ADDENDUM NO. 2

**RE: Item #3, September 18, 2024 Letting - IM 0902(189)98, PCN 09Q9, Pennington County -
Replace Sewer Lines**

48" Manhole Cover Slab
N.T.S. 3 / 15

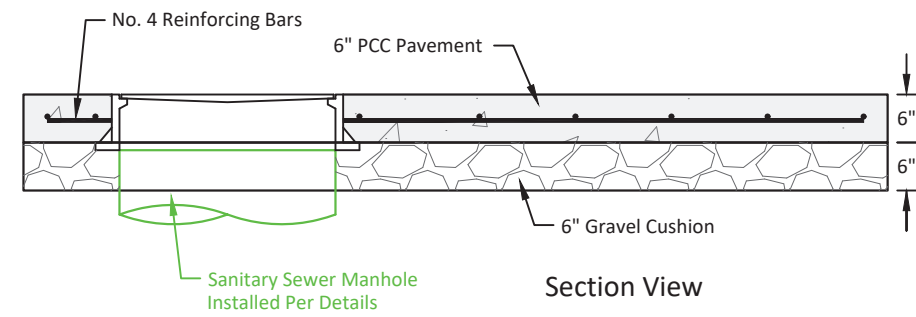
Sheet 13: Concrete Manhole Collar detail was renamed to 48" Manhole Cover Slab. Payment notes for the 48" Manhole Cover Slab and Gravel Cushion were added.

Plan View
Payment for 48" Manhole Cover Slab shall include the materials, labor and equipment to construct the concrete slab including reinforcing per the detail shown.

All work related to the compaction, grading, and gravel cushion below the slab will be paid for with the respective bid item.
